BOARD OF WATER SUPPLY

October 24, 2018

Subject: Board of Water Supply (BWS) Comments on the Navy's 2018 Conceptual Site Model Report, Investigation and Remediation of Releases and Groundwater Protection and Evaluation, Red Hill Bulk Fuel Storage Facility, dated July 27, 2018

Figure 2. Water levels during early October 2017 corrected for barometric effects.

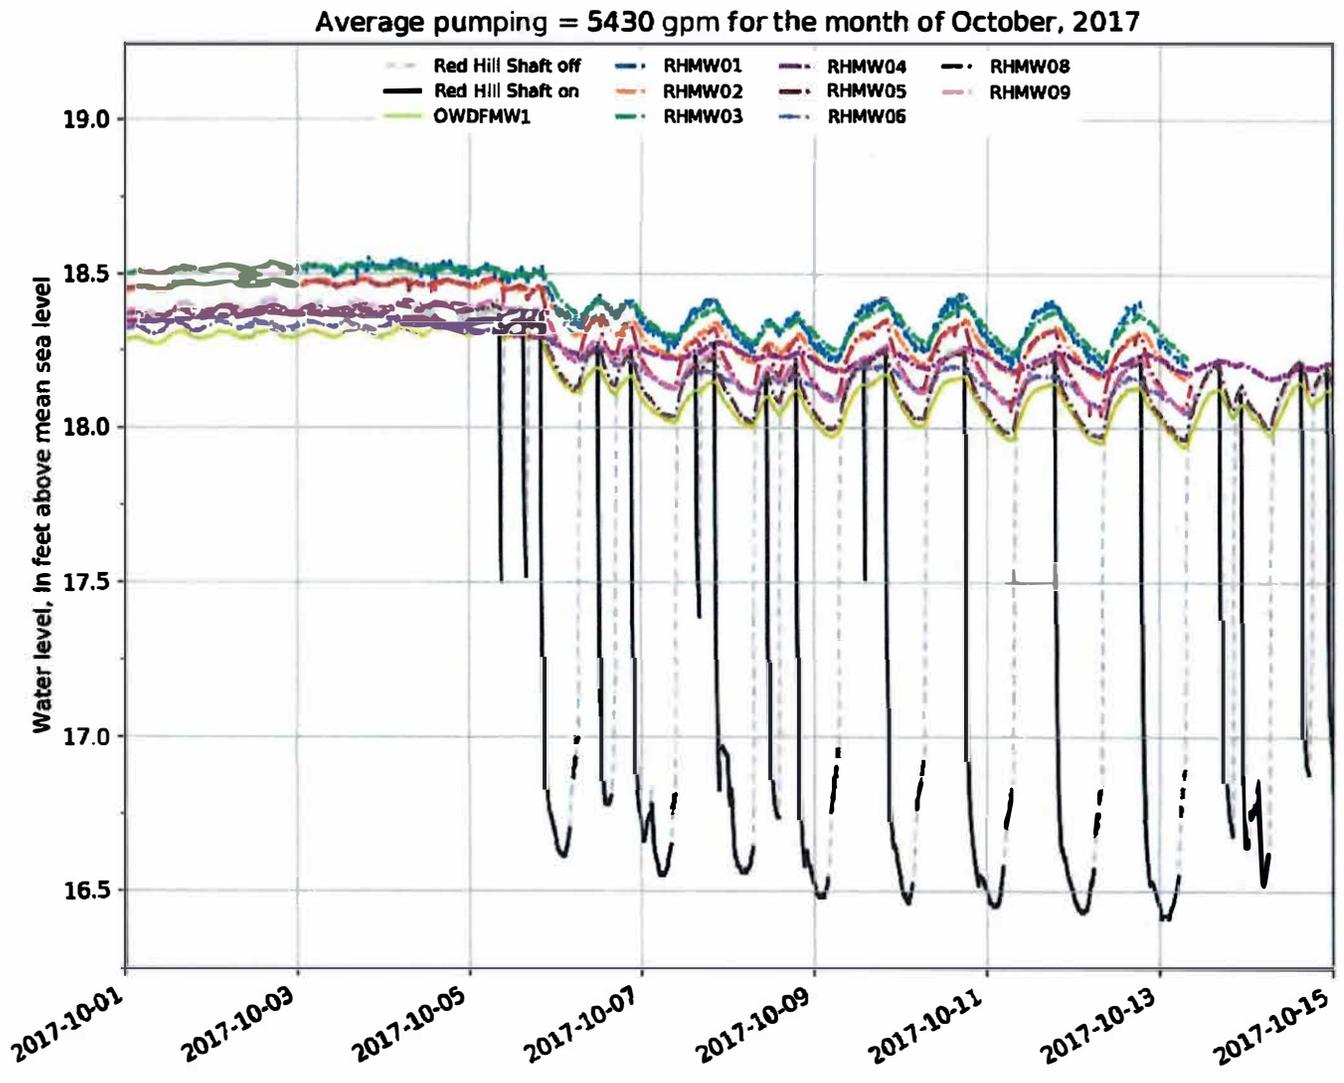
- b. Heads at monitoring wells RHMW03 and RHMW01 are essentially equal and higher than the head at monitoring well RHMW02 in early October

2017 (please see Figure 2 in Attachment A). Heads at monitoring wells RHMW02 and RHMW05 are nearly identical for the majority of the time.

Figure 3. Observed Water Levels for 9-day period where Red Hill Shaft was not pumping in late September and early October 2017

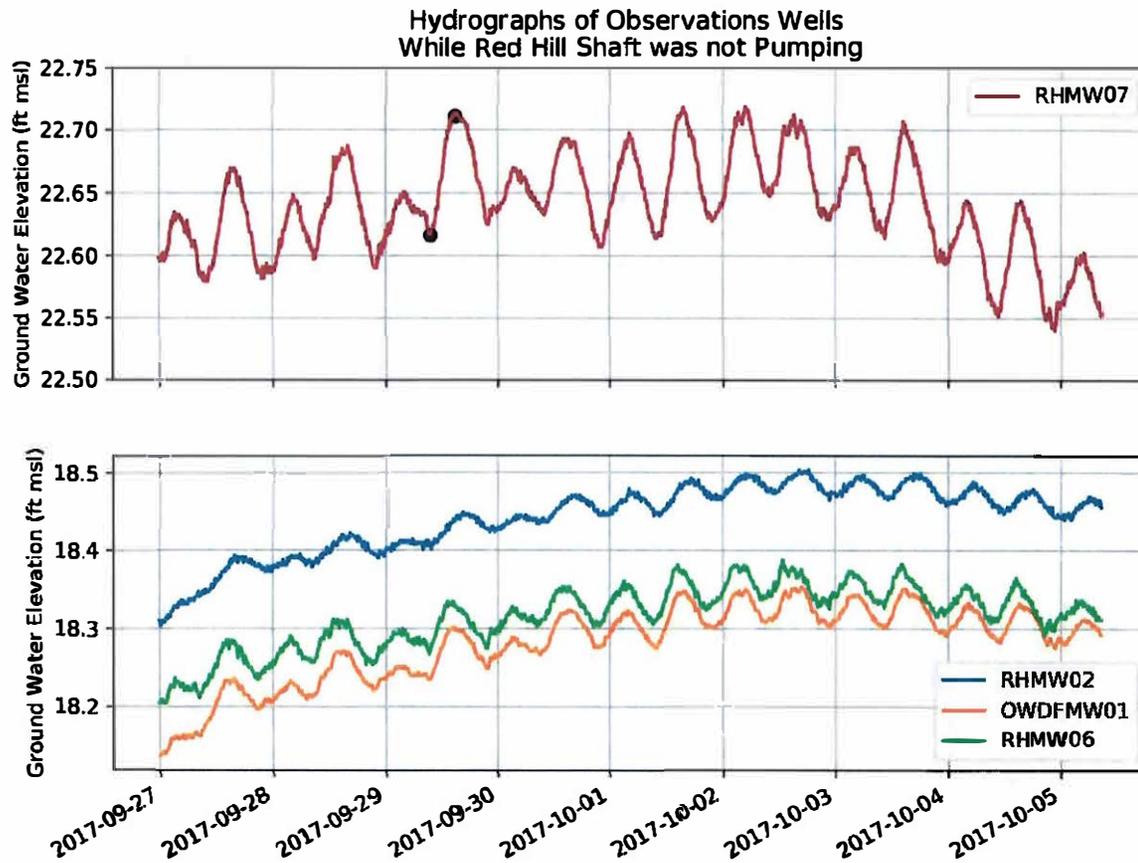
- a. Our preliminary analysis of water levels in the RHBFSF area indicates that water levels in the RHBFSF monitoring wells are affected by low-amplitude barometric pressure fluctuations in the atmosphere. Figure 3 (Attachment A) shows hydrographs measured between September 27 and

October 5, 2017 when Red Hill Shaft was not pumping. The hydrographs show oscillations in the water level at monitoring wells RHMW07, RHMW02, OWDFMW01, and RHMW06. (Note that the fluctuations in water level elevations are greater for monitoring well RHMW07 than for the other three wells). Contrary to the Navy's analysis, our preliminary analysis shows that all four monitoring wells respond to changes in barometric pressure and that the barometric efficiency calculated for each monitoring well is dependent on the time interval used for analysis. The BWS recommends that the Navy provide additional information to describe the assumptions and procedures used to calculate barometric efficiency in Table 6-5 and to document what is meant by "no response."

Figure 4. Corrected and Uncorrected water levels for well RHMW07 between late September and early October 2017

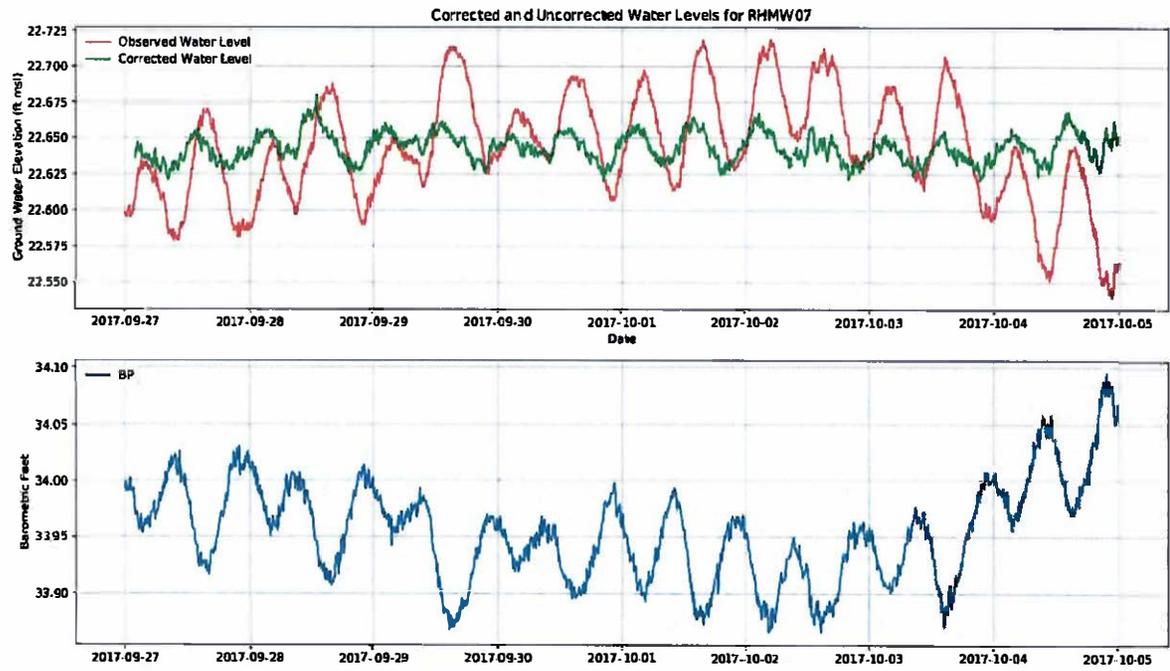
- b. Our preliminary analysis investigated removing the barometric pressure's effect on water levels (Toll and Rassmusen, 2007; Rassmusen and Crawford, 1997; Butler et al., 2011; Spane, 2002) using the 9 days in late September 2017 and early October 2017 of water level data. Barometric measurements collected at a nearby USGS gage; Aiea US Navy (187-B), Oahu, HI (USGS, 2018) were used with the Kansas Geological Survey's Barometric Response Function software (Bohling and others, 2011) to remove barometric effects on monitoring well RHMW07 (Figure 4 in Attachment A) as well as the other monitoring wells described in the CSM report.

Figure 5. Peaks and troughs of corrected water level at well RHMW02 associated to drawdown caused by Red Hill Shaft

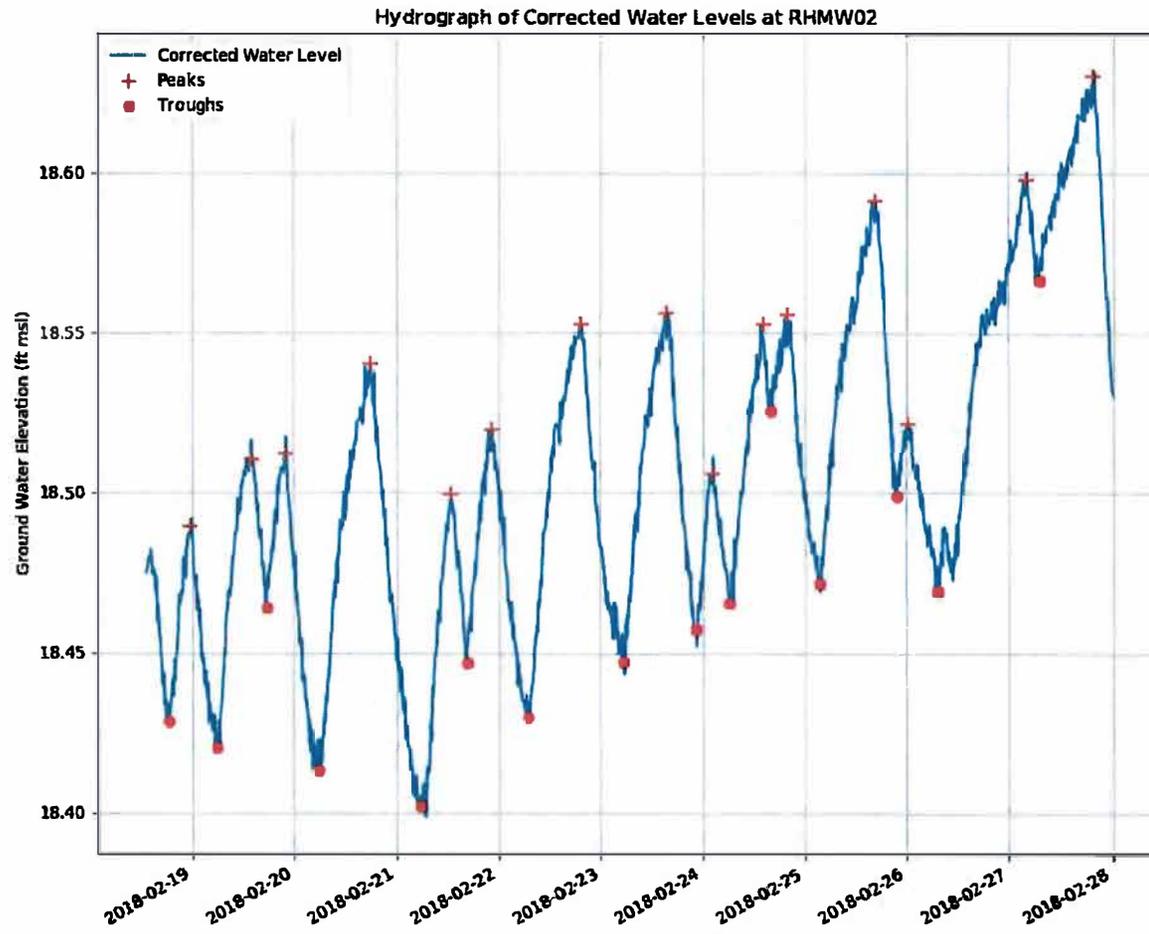
- b. However, drawdowns can be computed on a daily basis using the synoptic water level data to give much more realistic estimates of the amount of drawdown, how it varies with time, and can provide useful statistics for any period. The BWS defined drawdown as the difference between troughs and peaks for each day using barometrically corrected water level data. Figure 5 in Attachment A shows an example of monitoring well RHMW02 with the peaks indicated by "+" and troughs by "." during the period February 18 to 28, 2018.

- c. The BWS calculated maximum differences (as calculated between peaks and troughs shown in Figure 5 in Attachment A) observed over two periods of roughly 10 days when Red Hill Shaft was pumping relatively consistently: February 18 to March 1, 2018 and December 8 to 18, 2017 for monitoring wells RHMW01, RHMW02, RHMW03, OWDFMW01, RHMW06, and RHMW07 and computed an average maximum for each well. Average maximum drawdown during the February to March 2018 time period was 0.16 ft for monitoring well RHMW01, 0.11 ft for monitoring well RHMW02, 0.09 ft for monitoring well RHMW03, 0.08 ft at monitoring well RHMW06, 0.03 ft at monitoring well RHMW07, and 0.13 ft at monitoring well OWDFMW01. Average maximum drawdown during the December 8 to 18, 2017 time period was 0.20 ft for monitoring well RHMW01, 0.14 ft for monitoring well RHMW02, 0.12 ft for monitoring well RHMW03, 0.10 ft at monitoring well RHMW06, 0.04ft at monitoring well RHMW07, and 0.16 ft at monitoring well OWDFMW01. Thus, averaged maximum drawdown values over these two periods with relatively consistent pumping at Red Hill Shaft are far smaller than the drawdowns presented by the Navy in the CSM report in Figure 6-13. Drawdowns in Figure 6-13 were calculated using the highest water levels associated with maximum recovery, which occurred on January 15, 2018, and from the lowest water levels, which occurred on January 19, 2018. The BWS recommends that the CSM also include a figure that shows drawdowns that are more reflective of daily conditions. The BWS believes that the averages of daily drawdown are better suited than maximum drawdown values for estimating a capture zone for Red Hill Shaft. The Navy should make clear how they intend to pump so that the all SMEs can understand how Red Hill Shaft is affecting groundwater underneath the RHBFSF fuel tanks and elsewhere.

Figure 6. scatter matrix for the corrected water levels at the observation wells in late September and early October 2017 while Red Hill Shaft was not pumping

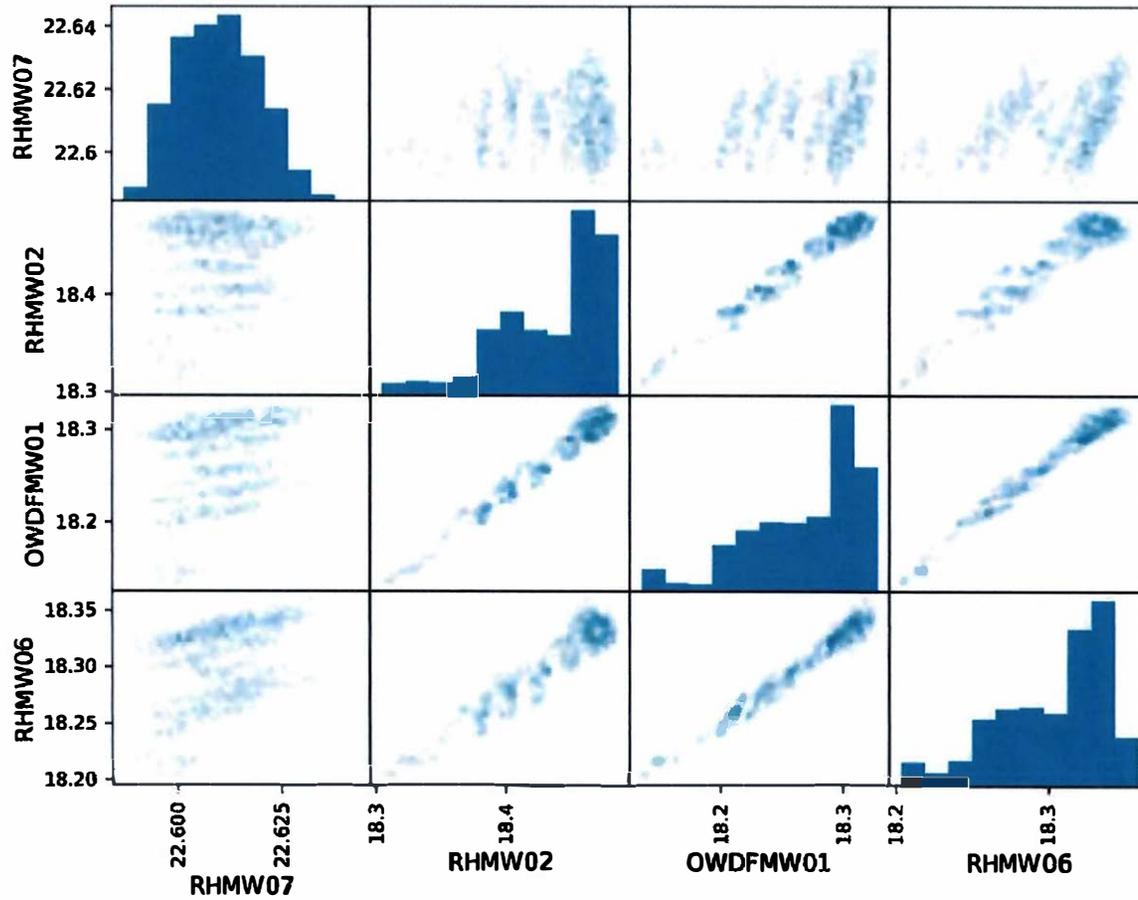
- b. Figure 6 in Attachment A shows that there is essentially no correlation in the water levels at monitoring well RHMW07. However, the water levels from the other three monitoring wells (RHMW06, OWDFMW01, and RHMW02) are correlated.

Figure 7. Comparison Hydrographs for RHMW07, RHMW02, and RHM06 and cumulative precipitation

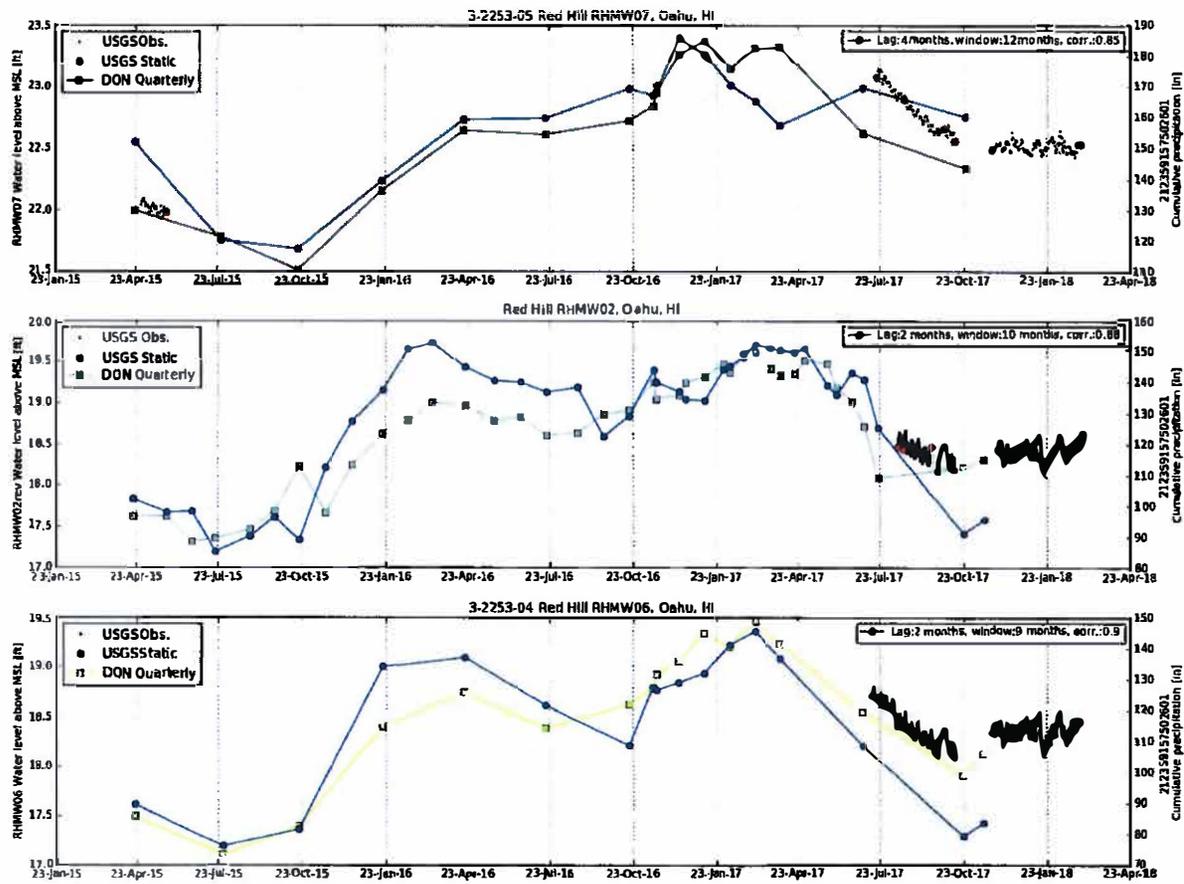
- d. The BWS recognizes that recharge and associated changes in water levels may not be directly related solely to the amount of precipitation per event, but rather related to a combination of historical and current precipitation. The BWS explored the relationship between the quarterly groundwater levels shown in Figures 6-1 and 6-2 of the CSM report and cumulative precipitation from daily precipitation records at climate stations in the Moanalua valley (USGS, 2018d). Cumulative precipitation was calculated for different windows of time (between 1 and 12 months) and plotted against quarterly groundwater levels provided by DON (2018) after being lagged by different lags (between 0 and 12 months). For each combination of lag and time window the correlation between water levels

and corresponding cumulative precipitation values was calculated. The agreement between cumulative precipitation and quarterly groundwater levels is high with correlation coefficients between 0.85 and 0.90. Figure 7 in Attachment A shows the window of time and lag that has the highest correlation to the quarterly levels. In the case of monitoring well RHMW07, the cumulative period is 12 months and the lag is 4 months, while for monitoring wells RHMW02 and RHMW06 the lag is 2 months and the cumulative periods are 10 and 9 months, respectively.

Figure 9. Hydrographs of RHMW07 vs. RHMW02 matching the same extent of Figure 6-1.

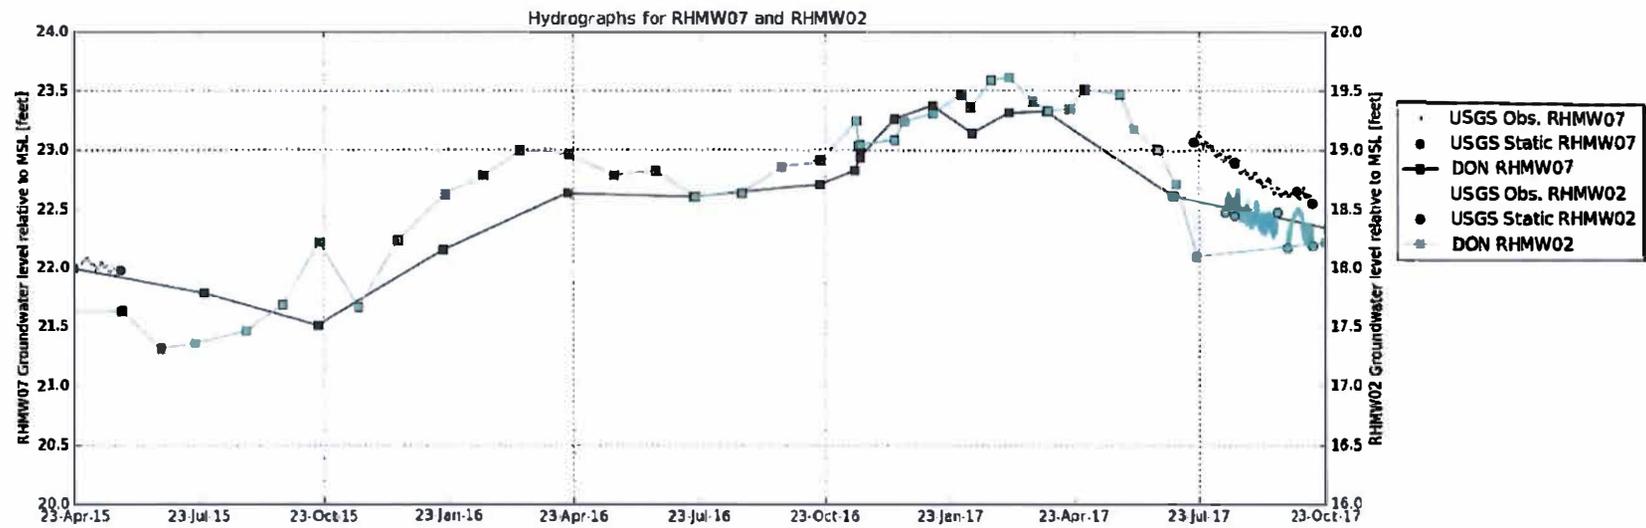
2. Figures 6-1 and 6-2 of the CSM Report: Both figures have errors in the plotted values and so should either be removed or revised.
 - a. Figure 9 in Attachment A combines hydrographs for monitoring wells RHMW07 and RHMW02 using both quarterly values reported by DON and available USGS synoptic and static observations. To facilitate comparison, Figure 9 in Attachment A uses the same groundwater elevation ranges and vertical marks used in Figure 6-1 of the CSM report. Visual comparison of Figure 9 in Attachment A and Figure 6-1 in the CSM report shows that monitoring well RHMW02 values in Figure 6-1 of the CSM report are shifted by three months (for example, the 18.2 ft value for October 23, 2017 shows the reported values around January 2018 in Figure 6-1 of the CSM report). Figure 9 in Attachment A also shows the apparent discrepancy between the monitoring well RHMW07 static levels and synoptic levels reported by the USGS and the quarterly levels reported in the CSM report between July and October 2017. In this period, the linear interpolation between quarterly values in the CSM report is constantly below the envelope of synoptic and statics levels reported by the USGS, whereas it shows a much closer agreement in April 2015.

Figure 10. Hydrographs of RHMW07 vs. RHMW06 matching the same extent of Figure 6-2

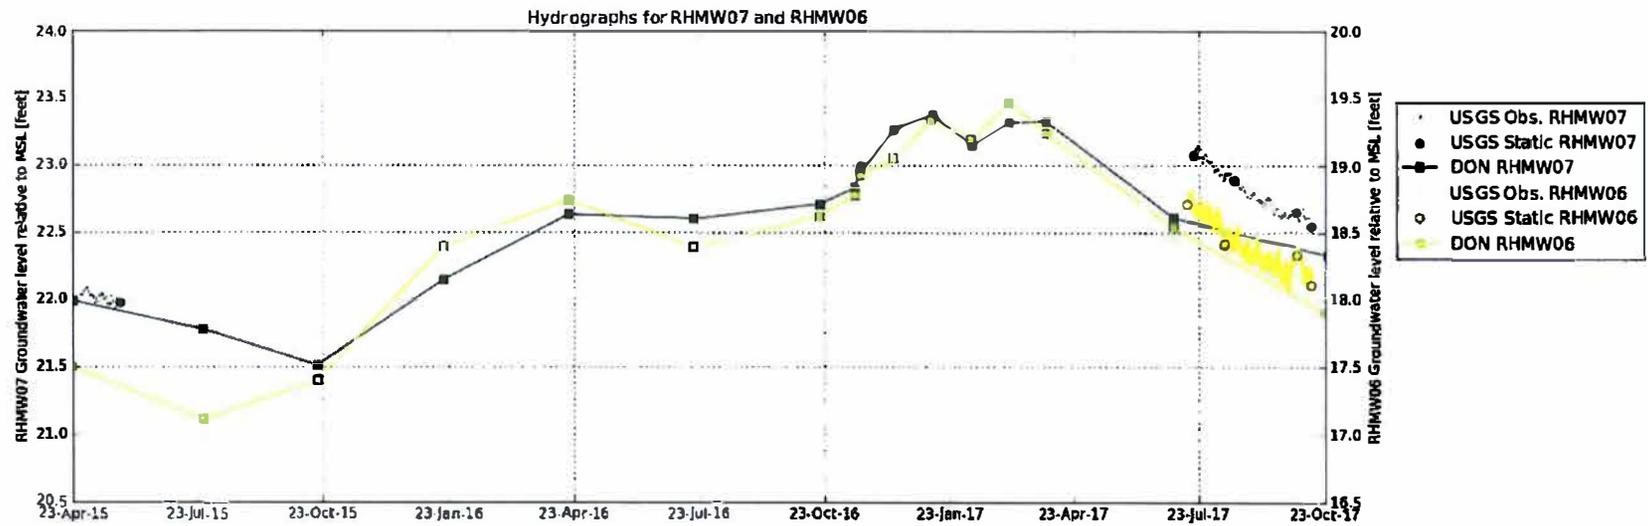
- b. Figure 10 in Attachment A combines hydrographs for monitoring wells RHMW07 and RHMW06 using both quarterly values reported by the Navy and USGS observations using the same vertical marks used in Figure 6-2 of the CSM report. In this case, the elevation range (16 to 20 ft) for monitoring well RHMW06 is not the same as the one reported in CSM report Figure 6-2 (13.5 to 17 ft) where values are shifted by 3 ft. Similarly, the linear interpolation between quarterly values reported by the Navy in the CSM report is constantly below the envelope of synoptic and statics levels reported by the USGS.
